**Brookhaven National Laboratory**  
**Plant Engineering - E&CS Division**  
**Engineering Change Notice Form**

**PROJECT:** CCWF II

**ECN Title:** Cooling Tower Site Plan

**ECN No.** 41A

Affected Documents: ES-401

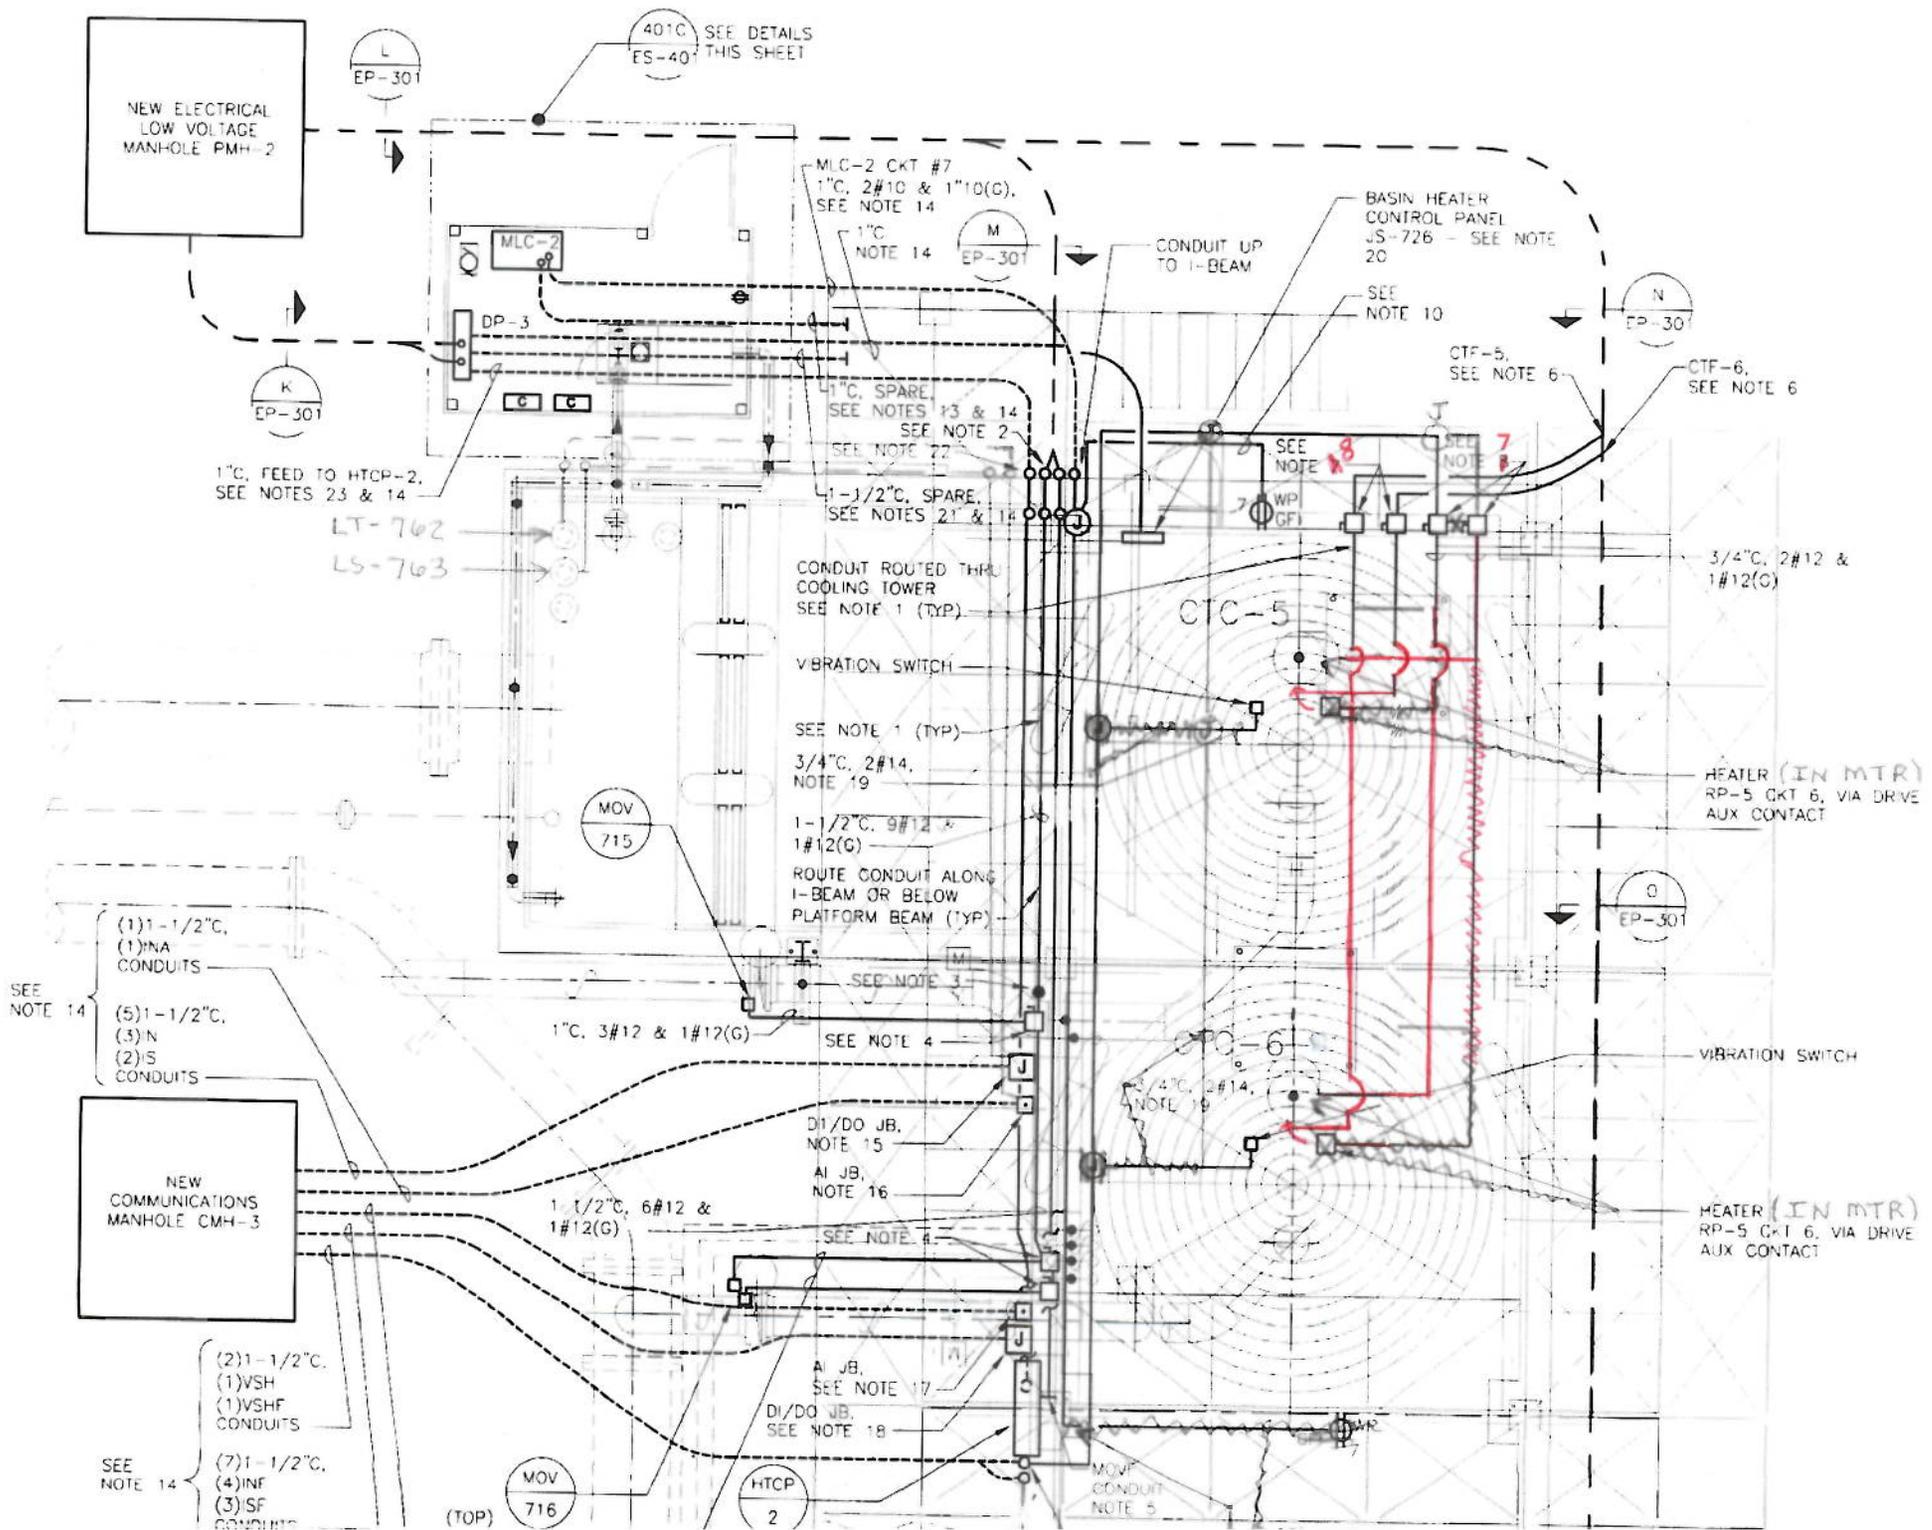
Revise Cooling Tower Disconnect Switch Locations for the Cooling Tower Fan Motors and Cooling Tower Motor Heaters

Resolution: See attached sketches. *(as built)*

12. STUB-UP 1-1/2" CONDUIT AT ~~CONTAINMENT WALL~~ *APPROXIMATELY 12" ABOVE GRADE* AND CAP FOR FUTURE EXTENSION TO CELLS 7, 8 & 9 VIBRATION SWITCHES AND MOTOR HEATERS.
